TECHNICAL BULLETIN — JUNE 2008

## 344. Mondial Top Scan

2. Location of cracking on the chassis.

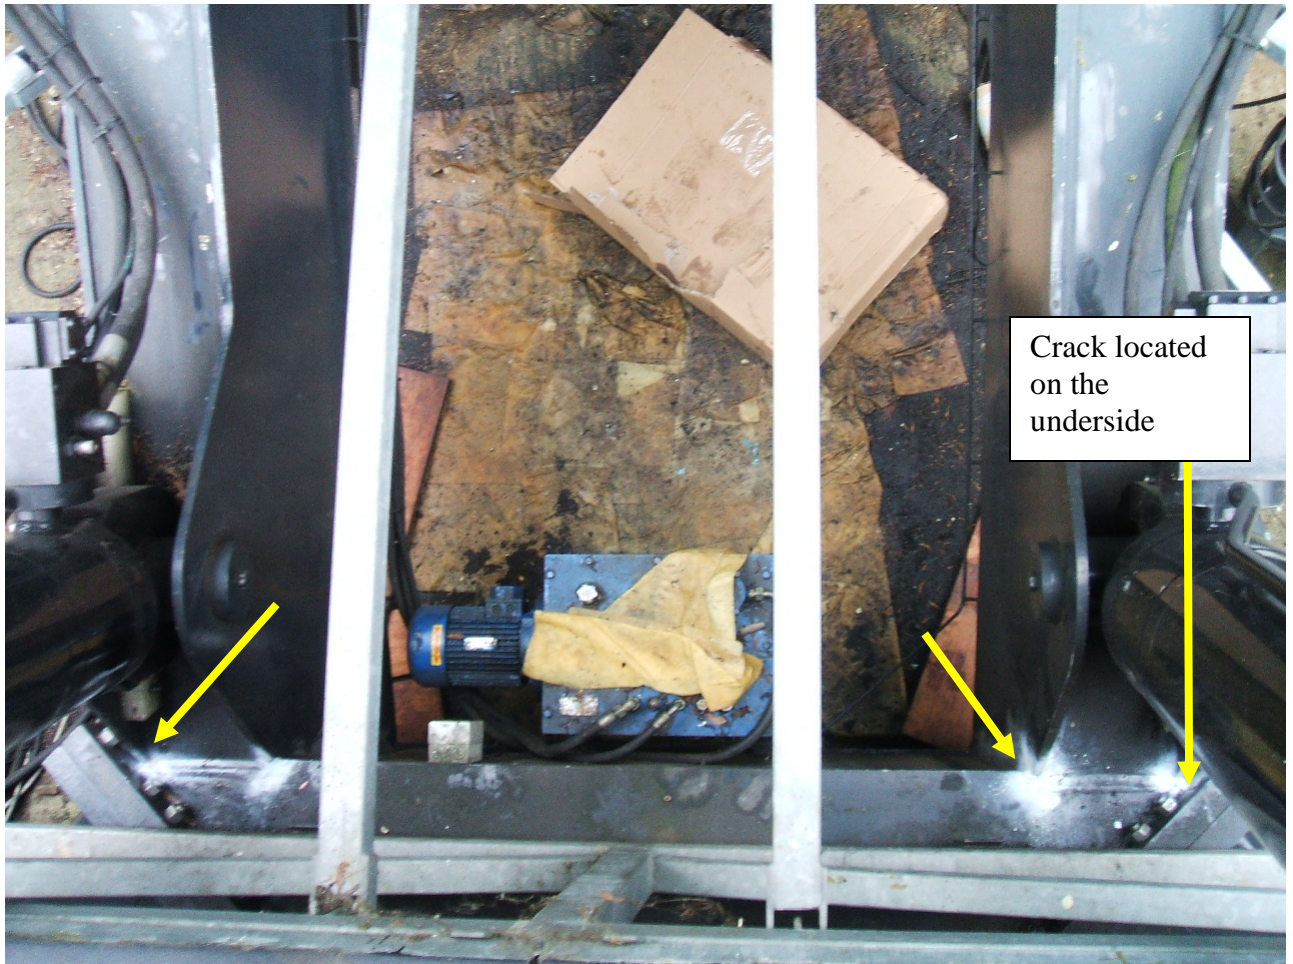
We have been informed by Leisure Technical Consultants Ltd. of defects on the Mondial Top Scan or Top Buzz device. The cracking is located in the outrigger – chassis weldments as shown below.

Figure 2 shows the location as viewed from above,

A repair procedure must be obtained from Mondial prior to any repairs being carried out.
